# ***Environmental and Sustainability Committee Meeting Business Paper***

4.1	Cumbalum Urban Release Area C - Rezoning Review	
	Attachment 1: Councils Request for Further Information.....	3
	Attachment 2: DPHI letter advising of rezoning review.....	14
	Attachment 3: BRS letter requesting a rezoning review .....	16

**Re: Additional Information Required for CURA C Rezoning Planning Proposal**

Figure 1: Developable areas and open space / drainage areas as identified in the RPS Urban Design Report

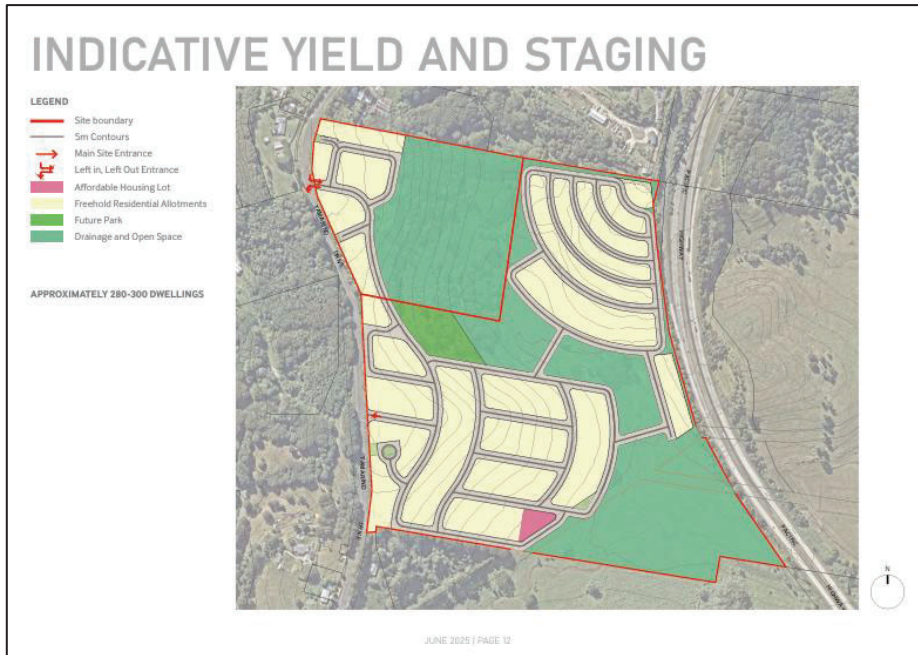
The Urban Design Report (RPS) provides an opportunities and constraints analysis which informs a range of other site layout design considerations. There is a disconnect between the land identified for drainage and open space and what has been submitted in the proposed zoning and associated minimum lot size (MLS) maps.

Please identify if any land within the proposed R3 zone is suitable for future residential development, or alternatively, amend the proposed zoning and associated MLS maps to reflect the intended use as open space and drainage. Please refer to maps below.

Council RFI	Comment
<b>1. Strategic Planning and Urban Design</b>	
Development Footprint / Appropriate Zoning	<p>The proponent has undertaken a review of the proposed rezoning, resulting in minor adjustments to the zoning layout. The updated rezoning plan is shown in <b>Figure 4</b>.</p> <p>The key changes are:</p> <ul style="list-style-type: none"> <li>• C2 Environmental Conservation Zone increased from 7.5 ha to 10.1 ha;</li> <li>• R3 Medium Density Residential Zone reduced from 36.5 ha to 3 ha; and</li> <li>• Introduction of the R2 Low Density Residential Zone, with 31.2 ha of the site now allocated to R2.</li> </ul> <p>A revised zoning plan is provided in Attachment 3.</p> <p>A factor informing the shift from the previously proposed R3 Medium Density Residential zone to an R2 Low Density Residential zone is the recent Ballina LEP amendments, which align with broader State Government policy directions and the Housing SEPP initiatives. These strategic planning reforms are intended to standardise permissible residential typologies across R zones, enabling a variety of housing forms to be permitted in lower density zones.</p> <p>As a result, the intended residential outcomes for the site can be delivered under the R2 zone without the need to pursue an R3 zoning. The R2 zone therefore remains consistent with Council's strategic intent while still facilitating a diverse range of housing types in accordance with State housing policy.</p>

Figure 3: Proposed access points

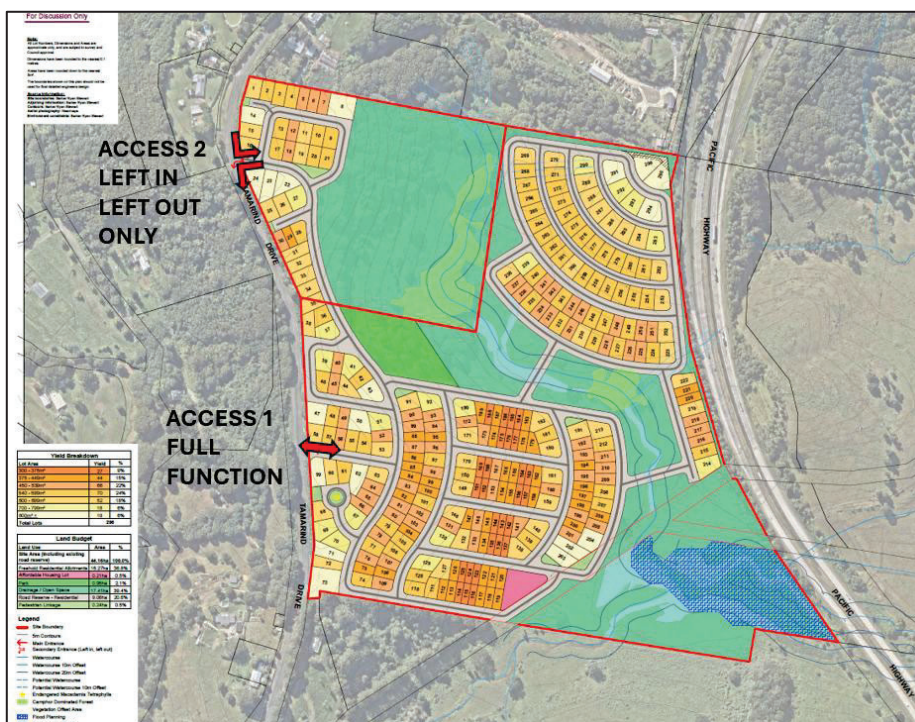
Access 1, located approximately 200 m south of the Lot 4/Lot 10 boundary is proposed as a full function with left in/out and right in/out movements provided. Access 2, located approximately 220 m north of the Lot 4/Lot 10 boundary is proposed as a left in/left out movements only.

The Bitzios TIA does not provide basic concept design plans with associated levels of the site road access. The TIA only provides a generic SIDRA schematic plan of "Intersection 5: Tamarind Drive/Development Access" indicating full function left in/out and right in/out movements. The SIDRA analysis then demonstrates that from a Level of Service/Saturation assessment the intersection performance is acceptable. The TIA does not provide the location of "Intersection 5" however it is assumed that this is the southern access as full functions are provided. There is no performance analysis of the second left in/left out intersection in the Bitzios TIA.

Insufficient information in the form of scale plans and levels (cross sections / long sections) has been provided to determine if the proposed intersections are feasible or safe. At both intersection locations there is significant level difference (several metres) between the development site and Tamarind Drive indicating there will be significant cutting earthworks and gradient required on the proposed access roads to connect the lower level of Tamarind Drive with the proposed development. The Tamarind Drive road reserve is also heavily timbered which has sight impacts. These matters will impact on the intersection design and whether these intersection locations are feasible or safe, and the extent of timber clearing and engineering works required on Tamarind Drive.

Access 2 is located immediately south of an uphill gradient (to the north) and significant curve on Tamarind Drive. The proximity of the curve and gradient on Tamarind Drive immediately north of the proposed access will cause significant risk of crashes (rear end) without appropriate intersection design to manage this risk. There is also a significant level difference between the development site and the lower surface of Tamarind Drive. Concept level intersection design detail is required to determine:

Site Access	<p>Updated concept plans have been prepared which show updated access intersections with the proposed subdivision. The details of each access intersection are as follows:</p> <ul style="list-style-type: none"> <li>• Intersection 1 (northern intersection) is a left in only intersection designed in accordance with the relevant Austroads standards. Given the lack of any exits onto Tamarind Drive, no further intersection analysis is required</li> <li>• Intersection 2 (southern intersection) is proposed as an all-movements intersection with an AUL for left turning vehicles and CHR for right turning vehicles. This intersection has been reassessed given the updated form and has been designed in accordance with the relevant Austroads standards. This intersection has also been relocated to top of nearby crest to ensure adequate sight lines can be achieved.</li> </ul> <p>Traffic volumes have been updated and are reflected in the SIDRA network assessment.</p>

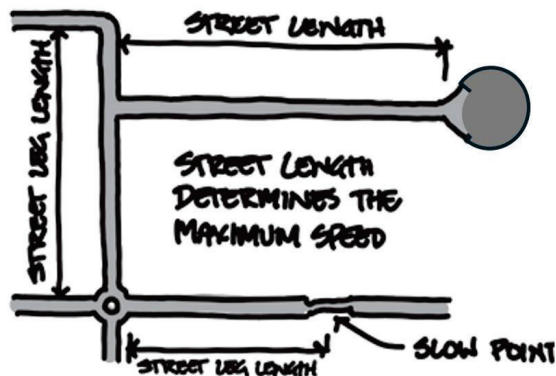
The RPS Urban Design Report's Movement Networks and associated subdivision concept plans are not satisfactory as the street layout has not been designed to control vehicle speeds to a safe level. Vehicle speed is primarily determined by length of straight (or large radius curves) between slow points and is also affected by road widths and road gradient. The long lengths of straight roads (and with steep gradients) as depicted in these plans are unsafe and will encourage high speeds.

The internal street network needs to be redesigned to provide shorter straights between T junctions/roundabouts or other acceptable slow points. Provision of slow points through traffic calming devices such as speed tables or speed bumps are not acceptable. It is also noted that DCP Chapter 3 requires that where land slopes at a grade of 6% or greater, the predominant road alignment is to be perpendicular to the slope.

Internal Roads/Urban Design	The conceptual road layout has been amended to demonstrate that the internal street network is capable of being refined to comply with DCP Chapter 3 requirements for inbuilt speed management, safe gradients and road alignment. The revised layout illustrates the ability to reduce long straight road segments, incorporate additional junctions and turning nodes, and orient road alignments more perpendicular to slope on land exceeding 6% grade. At the Planning Proposal stage, the purpose of the concept

Figure 4: Proposed Land Use Zoning Map after review (Source: BRS, 2025)

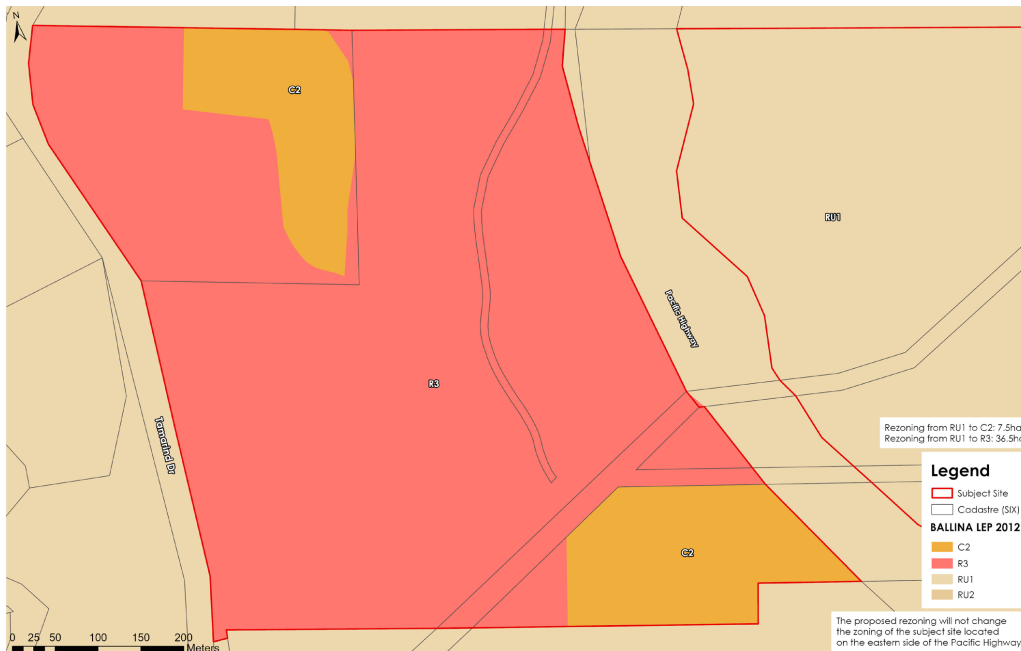
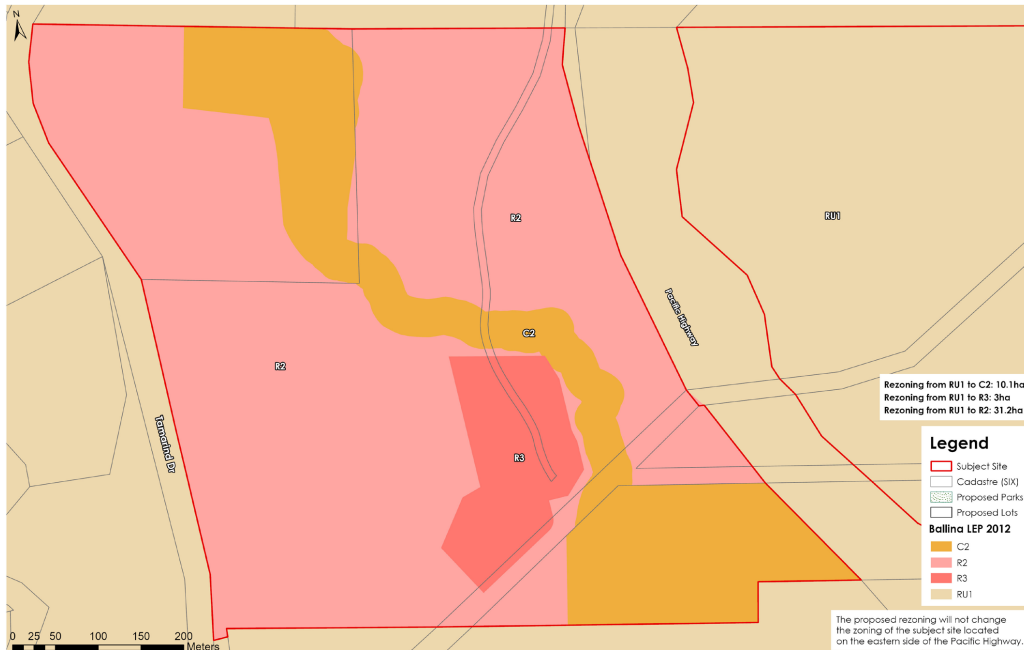
In response to Council's RFI and the amended LEP framework, an updated zoning plan has been prepared. This revised zoning map incorporates areas of R2 Low Density Residential zoning and a more refined application of the C2 Environmental Conservation zone, as shown at **Figure 4**.
